RE: Addendum 14 to the Work Plan for Rapid Response, Interim Corrective Measures,
and, Comprehensive Site Assessment
Coliseum Boulevard Project
Montgomery, Alabama

ALABAMA DEPARTMENT OF TRANSPORTATION
COLISEUM BOULEVARD PROJECT

GRID SPACING IN PROBEHOLE 12 AREA

FIGURE 2A

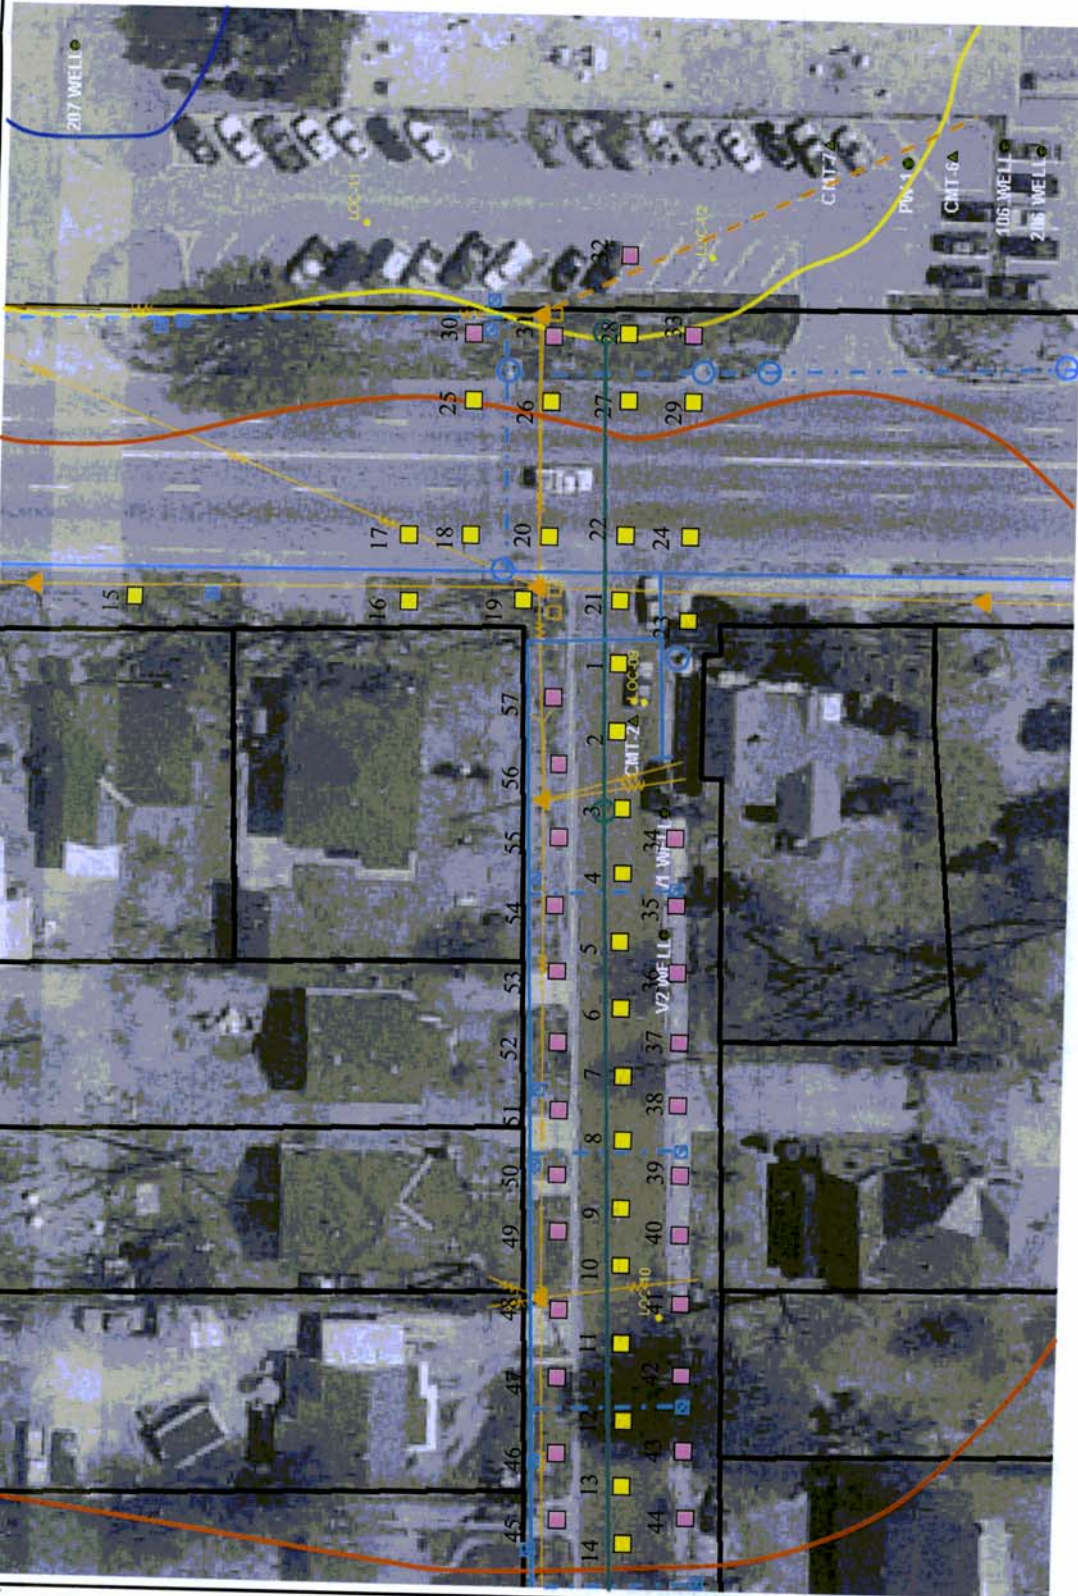
To facilitate a more detailed subsurface characterization of Pilot Test Area A, the ALDOT proposes increasing the density of sample locations from the 15 locations

proposed in Addendum 14. The attached Figure 2A shows locations of proposed probeholes and potential step-out locations. As discussed in the Addendum 14 Scope of Work, a soil-conductivity/MIP probe will be advanced at each location using direct-push methods in accordance with the procedures described in the Addendum 03 Scope of Work approved by ADEM. The MIP results will be used to characterize relative concentrations of TCE in the shallow aquifer and at select locations. Probeholes will be subsequently drilled to collect depth-discrete soil and groundwater samples for analysis of TCE and other parameters.

ALDOT also proposes to include cone-penetrometer testing (CPT) at accessible locations (see Figure 2A) to provide additional information on soil contrasts to detail stratigraphy. The CPT measurements will be advanced using direct-push methods in accordance with testing procedures outlined in the American Society of Testing and Materials (ASTM) method D-5778.
